STAFF REPORT: FEBRUARY 23, 2022 MEETING

APPLICATION NUMBER: 22-7660

ADDRESS: 31 ARDEN PARK

SCOPE: ERECT REAR/SIDE ADDITION

Western Architect, 1916

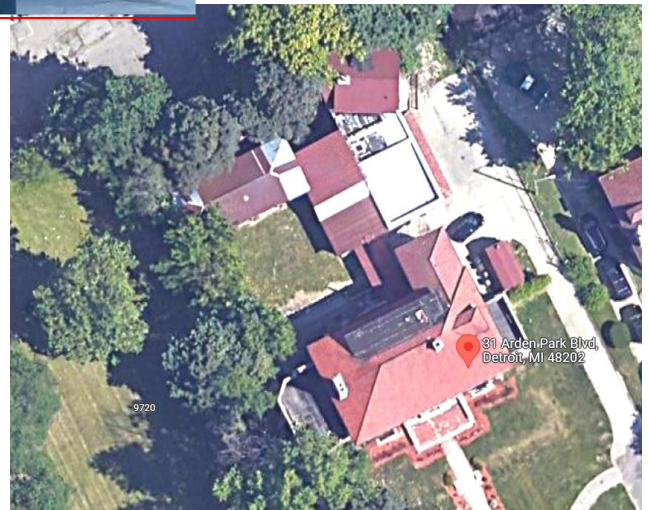
- It is staff's opinion the location of the shed negatively impacts the character-defining features of the house and site. The historic placement and relationship between the house/sunroom/garage is clearly shown in the 1916 image.

- Additionally, the shed's design is not compatible with the massing, size and architectural features of the house and garage.

It is staff's opinion the location of a garden shed and 8' high solid wood privacy fence, as erected, alters the features and spaces that characterize the property. Staff therefore recommends the Commission deny a Certificate of Appropriateness for the work as proposed because it does not meet the Secretary of the Interior Standards for Rehabilitation and the Elements of Design for the district.

2 | EAST ELEVATION
A00 | Scale: 1/8" = 1'-0"

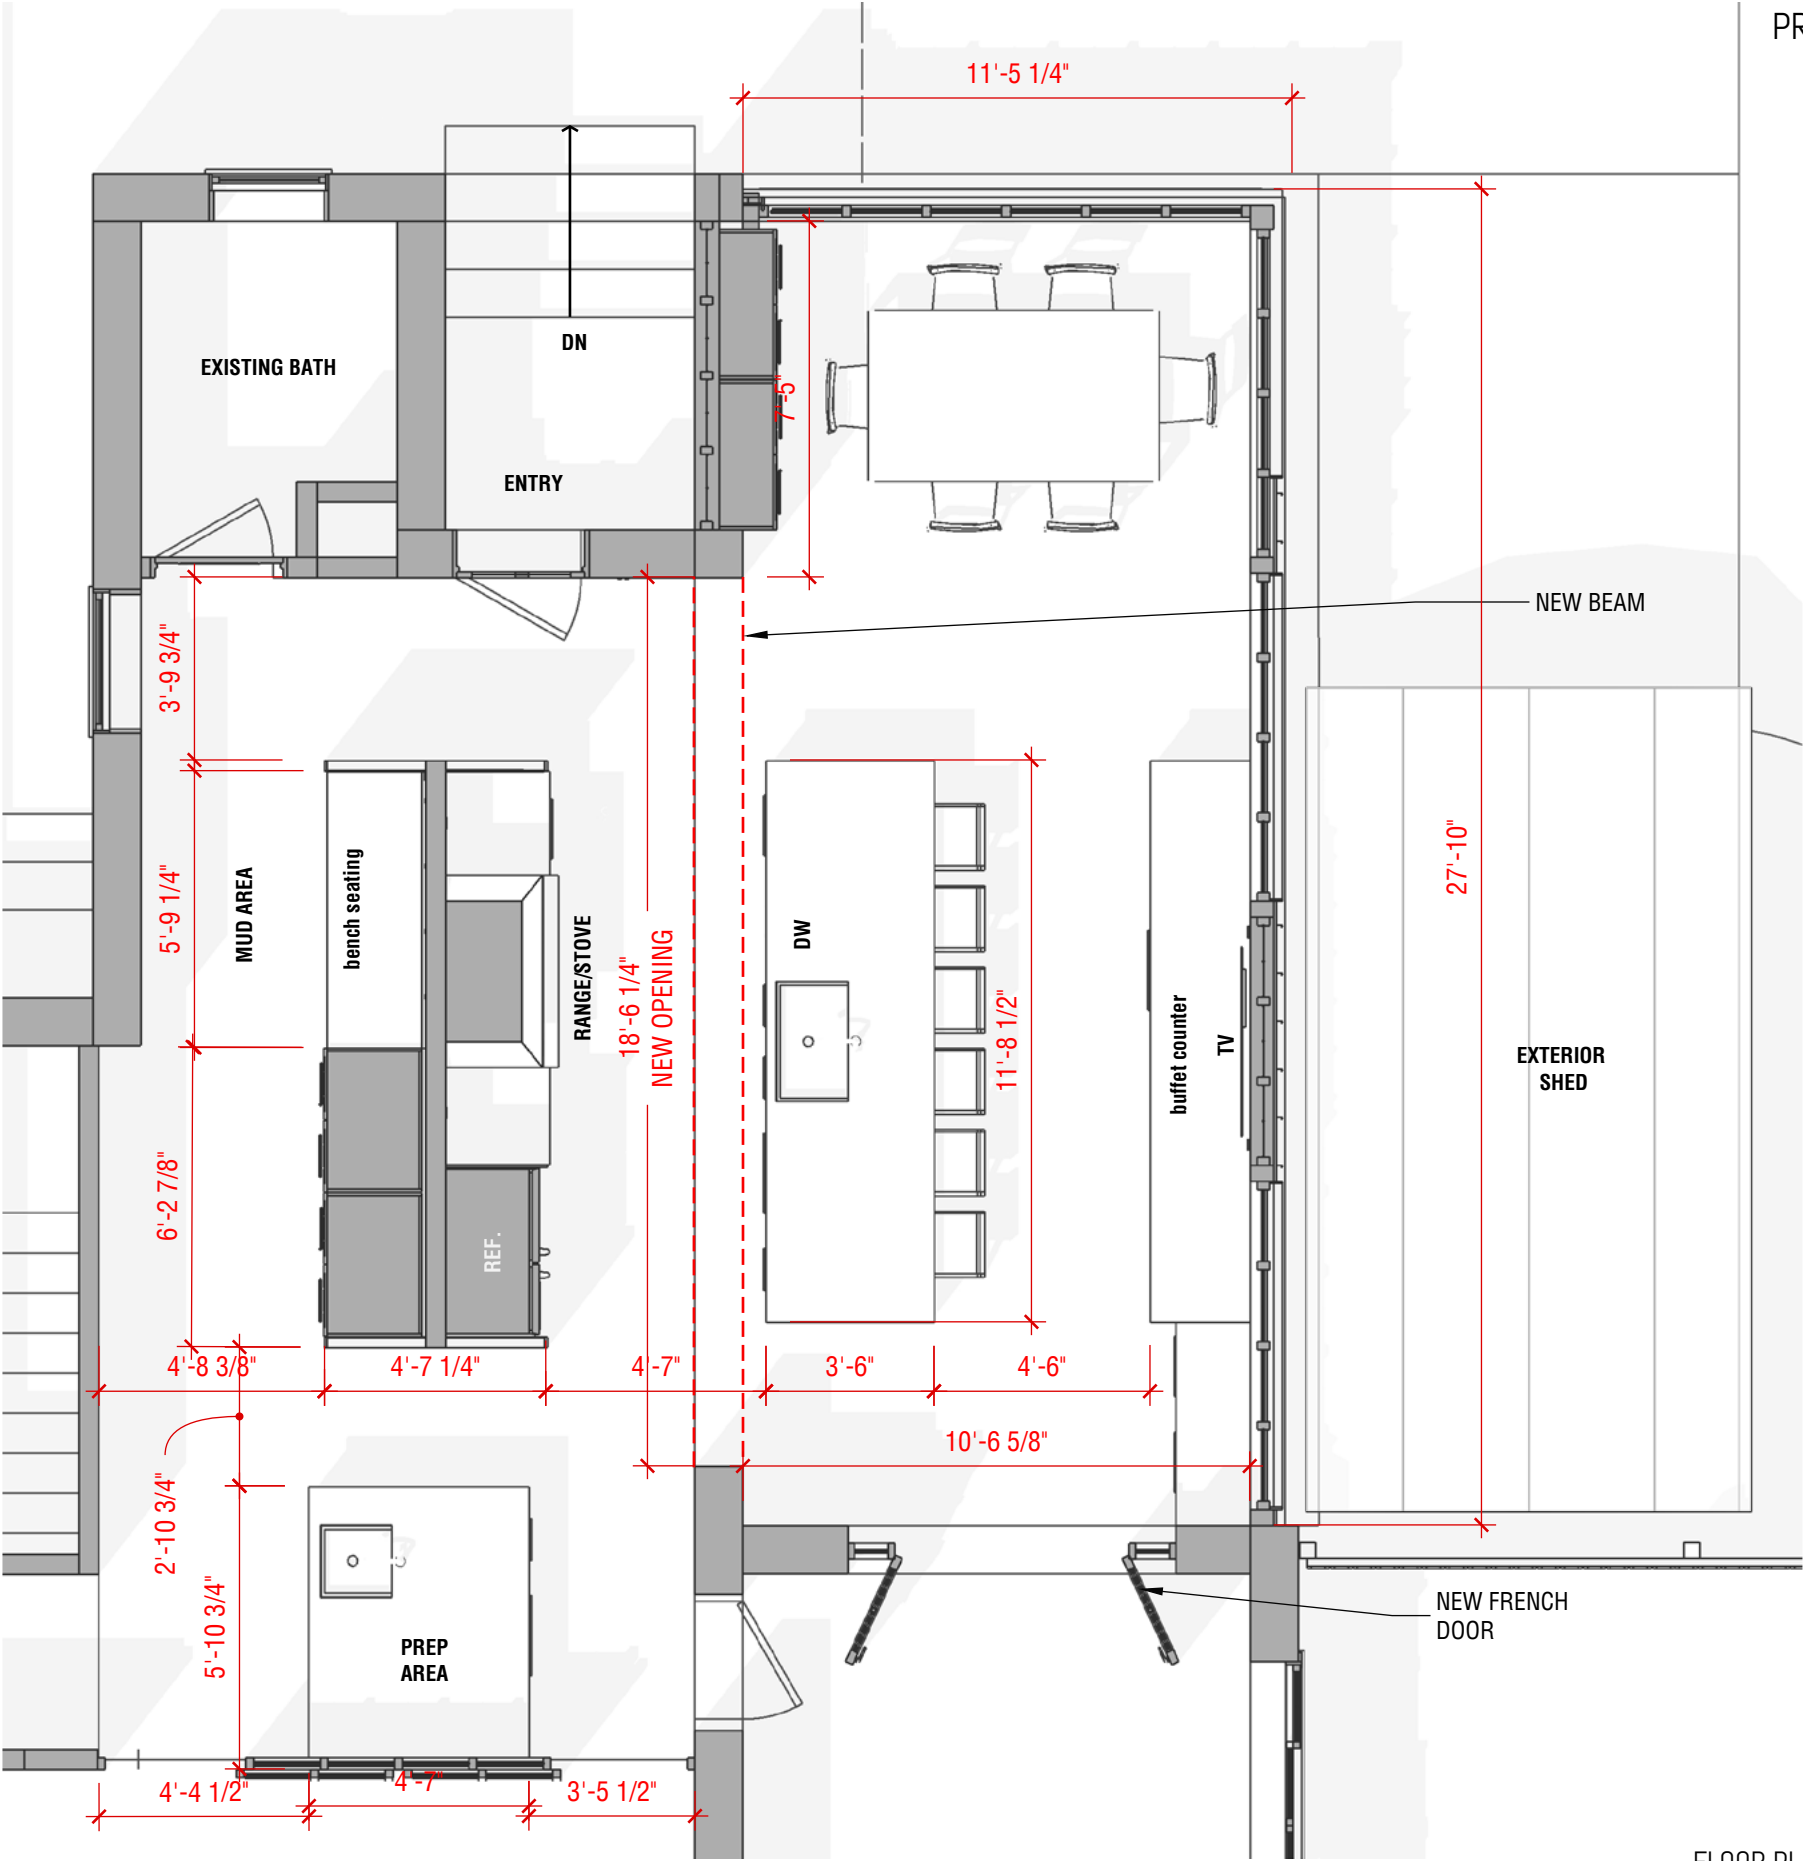
- All of the window openings offer little-to-no muntins which create expansive, transparent openings.
 - The casement windows in the proposed addition have 2x4 or 2x5 muntin patterns. This closely matches the windows in the adjacent sunroom (they have a 2x5 pattern). However, the windows on the sides and rear of the house are one-over-one double-hung sash. It is typical for windows on the front elevation (and highly visible side elevations, such as the sunroom) to have more detailed window units. Changing the casement sash to clear glass/no muntins would be a positive step in simplifying the facades and creating a more open atmosphere.

- The width and strong verticality of the proposed mulled window openings matches the sunroom's original openings. The sill height was carried over to the north and north-east elevations window openings. Matching dimensions of existing openings can be a strong design solution for an addition. Staff believes in this instance, the addition's purely modern design may allow for different sill/header heights to create more expansive openings, similar to those shown the precedent images. A wall section was not included with the application, so it isn't clear whether the window heights can be increased.

- The sill height for the openings closest to the sunroom are higher due to a kitchen counter and the wide width of the wall separating these window openings is due to the placement of a television. The inconsistent dimensions, coupled with the vertical and horizontal lines of the standing seam exterior, on a small, monochromatic addition, creates an awkward wall pattern, which is also counter to the precedent images.

- The exterior pattern and proposed installation method of black standing seam metal creates heavy vertical and horizontal lines which create a tremendous contrast to the house's buff brick with a low-relief mortar profile. Staff believes a metal panel can be an appropriate choice for this addition, however wide, flush wall panels (with minimal joints) in a neutral warm color could supply the requested contrast to the brick house. The middle precedent image (previous page), with a flat surface exterior and expansive window and door openings creates a unified plane that allows the eye to focus on the transparency of the windows, as well as the background brick pattern and multiple window openings on the main body of the house.

- The eave will be lowered so that it is well below the sunroom's stone band and will reduce the height of the wall above the windows.
- The exterior cladding will be a flat, flush metal panel with minimal joints. A warm color that coordinates with, but does not match, the buff brick will be submitted for staff review.
- The casement windows will have clear glass and no muntin patterns.
- The applicant will investigate designing the planters as an integral component of the addition. The planters will extend the length of the visible east wall. Or catalog cuts of the proposed free-standing planters will be submitted for staff review.
- The drawings, including submission of a wall section, roof plan, and catalog cuts of the skylights, shall be revised, and submitted to HDC staff for review.
